Access Compliance Report

Public Rights-of-Way

(Curb Ramps)

Intersection ID: 25815	Main Street: REA_RD	Cross Street: PINEVILLE-MATTHEWS_RD	Location: SW
ADA ID: ECB71571D278	Ramp Type: Perp	Initial Pass/Fail: Fail	Overall Compliance: No
Codes/Mitigation Info/Possible Solution		Field Measurements/Component Compliance

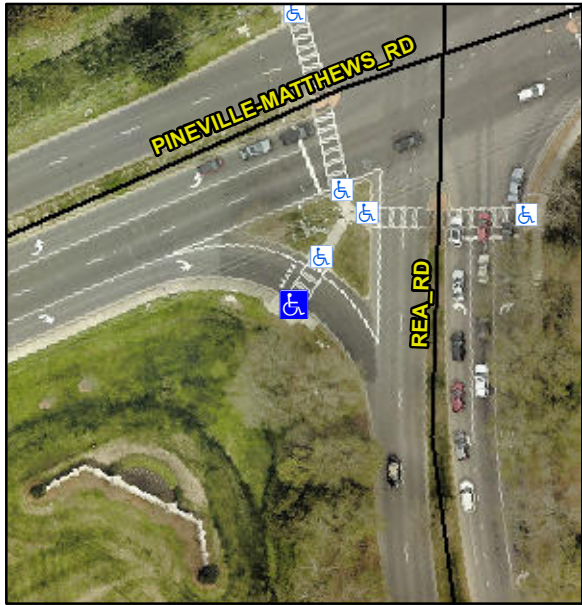
Not Found, R304.2.2, R304.5.3

Compliance	Description	Data	Compliance	Description	Data
N/A	Ramp Length (in)	60.0	No	Ramp Slope (%)	8.9
Yes	Ramp Width (in)	48.0	No	Ramp XSlope (%)	3.7
N/A	Flare Type LT	N/A	N/A	Flare Type RT	N/A
N/A	Flare Slope LT (%)	N/A	N/A	Flare Slope RT (%)	N/A
N/A	Flare Traversable LT?	N/A	N/A	Flare Traversable RT?	N/A
N/A	Landing Length (in)	N/A	N/A	DWS Provided?	N/A
N/A	Landing Width (in)	N/A	N/A	DWS Contrast?	N/A
N/A	Landing Slope (%)	N/A	N/A	DWS Length (in)	N/A
N/A	Landing X Slope (%)	N/A	N/A	DWS Full Width?	N/A
N/A	Landing Curb? (Y/N)	N/A	N/A	DWS Offset (in)	N/A
N/A	Shared Landing?	N/A			
N/A	Gutter Ponding?	N/A	N/A	Gutter Slope (%)	N/A
N/A	Gutter Lip Ht (in)	N/A	N/A	Gutter X Slope (%)	N/A
N/A	Painted X Walk1?	No	N/A	Painted X Walk2?	N/A
	X Walk 1 Direction	To NE		X Walk 2 Direction	N/A
N/A	X Walk 1 Width (in)	N/A	N/A	X Walk 2 Width (in)	N/A
	X Walk 1 Slope (%)	1.3		X Walk 2 Slope (%)	N/A
	X Walk 1 X Slope (%)	2.7		X Walk 2 X Slope (%)	N/A

Remove & Replace Entire Ramp.
